**SEQUOYAH FUELS CORPORATION
RESPONSE TO REQUEST FOR
ADDITIONAL INFORMATION
GROUND WATER CORRECTIVE
ACTION PLAN REVIEW**

Subject: Sequoyah Fuels Corporation, Docket – 40-8027
Request for Additional Information – Groundwater Corrective
Action Plan (TAC L52528)

Responses to NRC RAIs of September 28, 2005
Ground Water CAP Review

FIGURE 2-17
POTENTIOMETRIC SURFACE SHALE 4
JUNE 2001

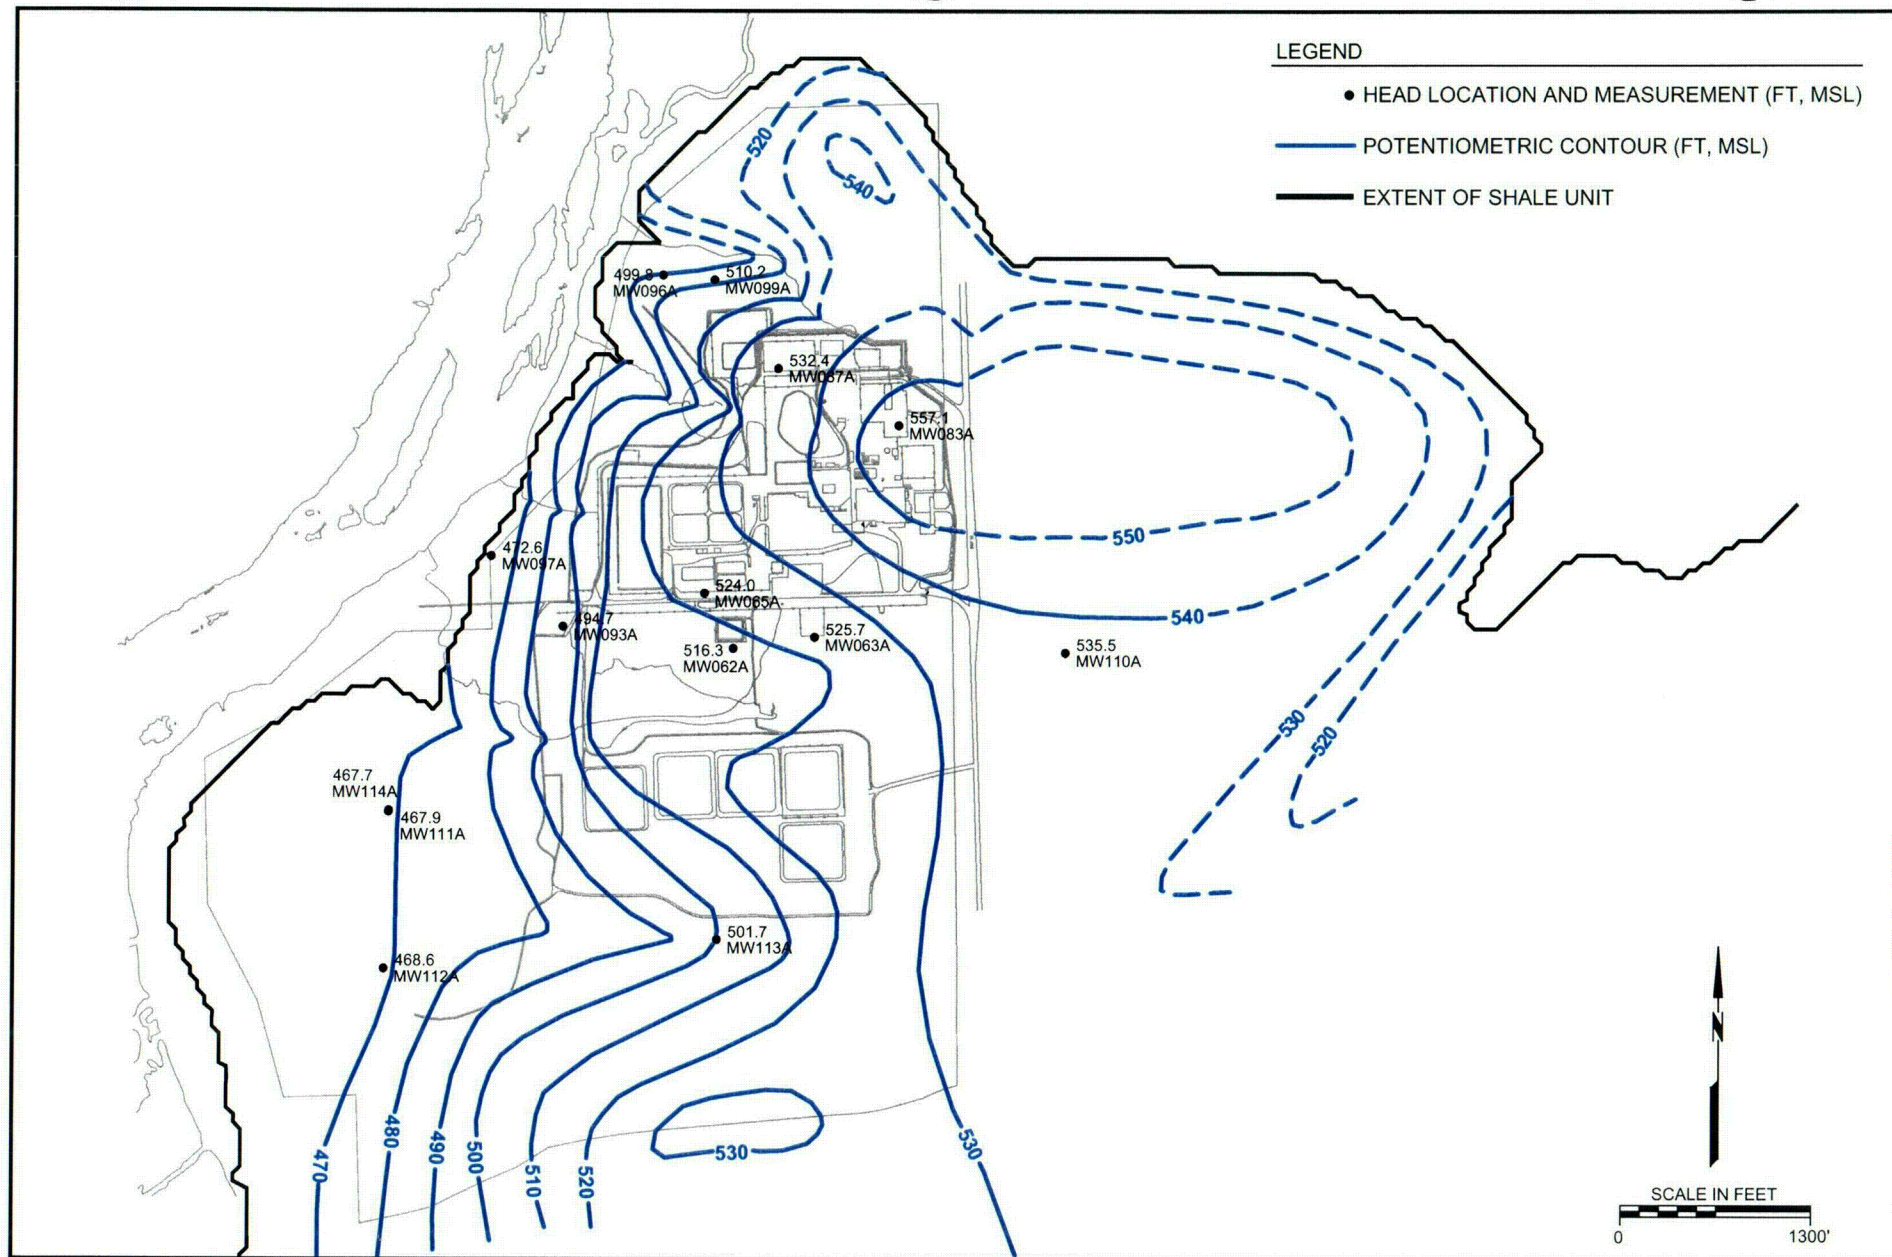
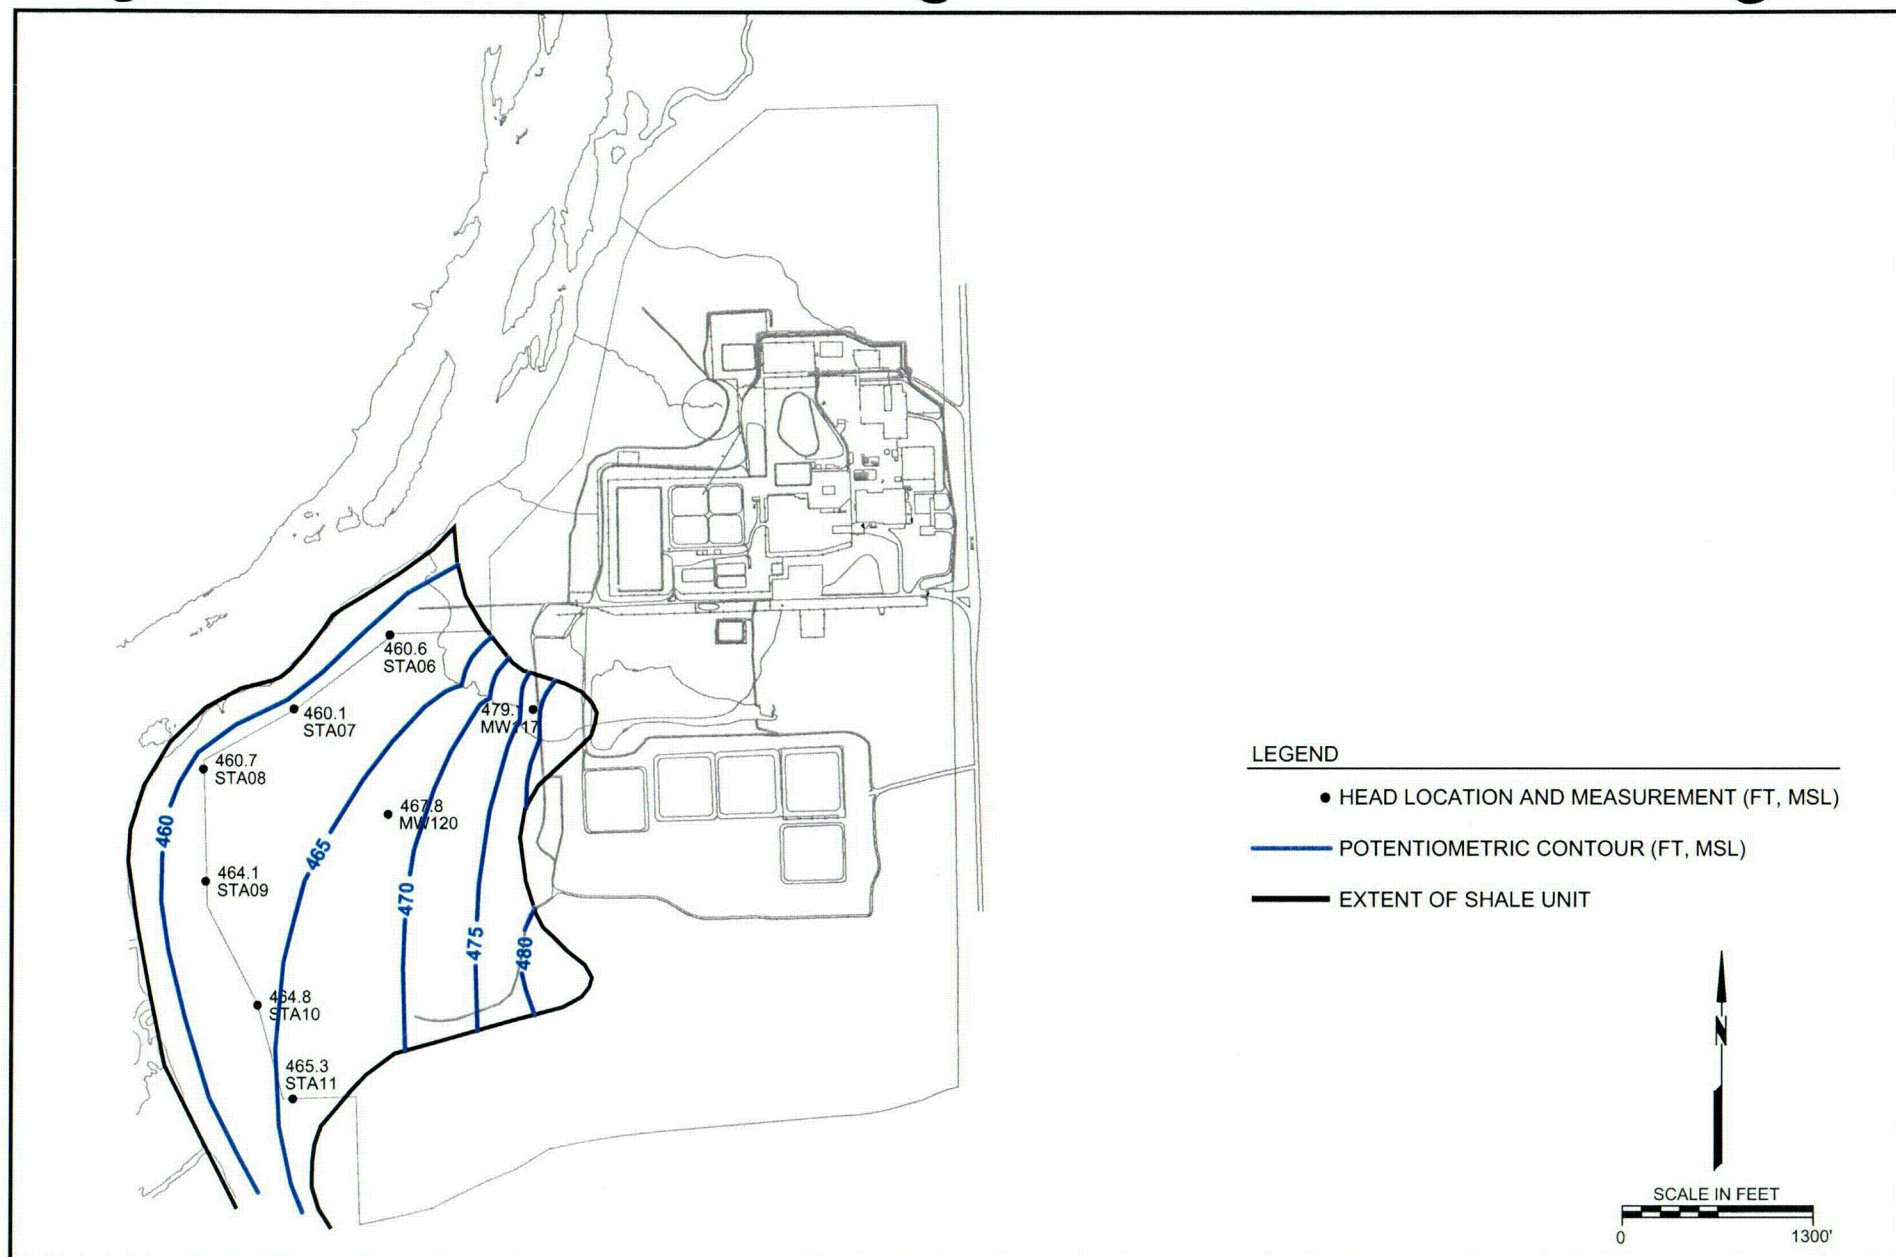
- B. Figures 2-8 through 2-13 contain geologic cross-sections; however, these also need to include the potentiometric surface of the uppermost aquifer and the locations and screen depths of ground-water monitoring wells used to measure the potentiometric surface. This information is necessary to examine the relationship between the potentiometric surface, site structures or features, and underlying geologic units. This information will allow NRC staff to evaluate whether extraction wells and trenches are placed in effective locations for capturing ground-water contamination.

- D. SFC should also present a discussion of the contouring method used to create potentiometric surface maps and should also present a contoured map of residuals. Discussions of the contouring method will allow NRC to evaluate the validity of the mapping procedure (not model validity). A residuals map will allow NRC staff to determine if data for certain areas of the site exhibits a high degree of uncertainty and whether such a condition would impact the selection of remedial alternatives.

CAP Figures 2-14 through 2-18 illustrate the measured potentiometric surface for the alluvium as well as Shale units 1, 2, 3, and 4 and the lateral extent of these units. Additional figures are attached to this response as Attachment CAP2B illustrating the modeled particle flow paths related to the corrective actions to illustrate the capture zones of each interception trench or recovery well. In addition, in response to Question CAP3B, a figure is included showing the entire industrial area with all site features, topography, remediation facilities (including corrective action trenches and dewatering wells), and color coded potentiometric lines for all saturated zones (Shale 1 through Shale 4). This figure is a composite of CAP Figures 2-14 through 2-18.

The hydraulic gradients for individual hydrostratigraphic units are identified graphically in CAP (2003) Figures 2-14 through 2-18 (Attachment CAP2C-3); the northings, eastings as well as measured and computed heads in specific wells are also provided in HGSCR (2002) in Table 8-3, which have been copied and included with these responses in Attachment CAP2C-4. From these figures and data, specific gradients of interest can be easily calculated.

The data used to develop the potentiometric contours are posted in Figures 2-14 through 2-18 (Attachment CAP2C-3). Due to limited data and boundary effects associated with computer contouring, these contours were generated by hand based on professional judgment by a qualified hydrogeologist. There are no residuals (difference between measured head and contoured head) to be mapped since the precise measured heads were used to generate the contours. The residuals for the calibrated flow and transport model are presented in Table 1 of the March 7, 2005 Technical Memorandum regarding revisions to the ground water model submitted to the NRC on March 14, 2005 as part of the first round of responses to RAI's on the Ground Water Corrective Action Plan.
